# CITY OF ALBUQUERQUE

**Re: Advanced Auto Parts  
2807 San Mateo Blvd., NE  
30-Day Temporary Certificate of Occupancy- Transportation Development  
Engineer's/Architect's Stamp dated 8-7-15 (H17-D111)  
Certification dated 4-8-16**

TRAFFIC CIRCULATION LAYOUT

PROJECT NO:	CAD008.01
DESIGNED BY:	JDC
DRAWN BY:	JDC
DATE:	08/07/2015
<b>C1.2</b>	
SHEET 1 OF 2

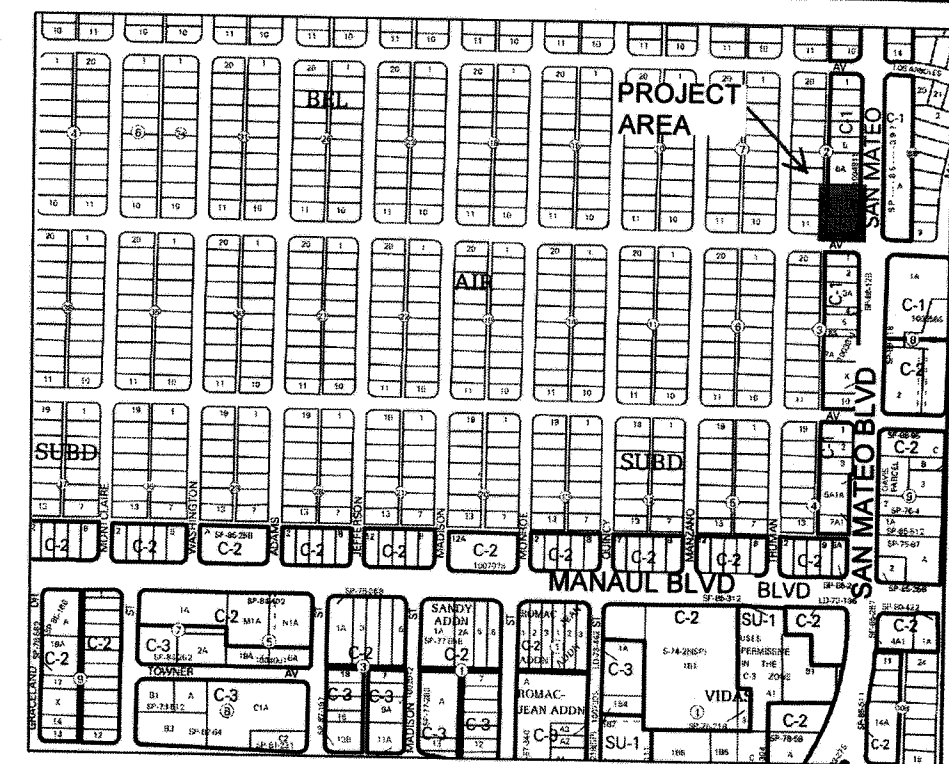
- Correction of Truncated domes at the intersection of Claremont Ave. and San Mateo Blvd.
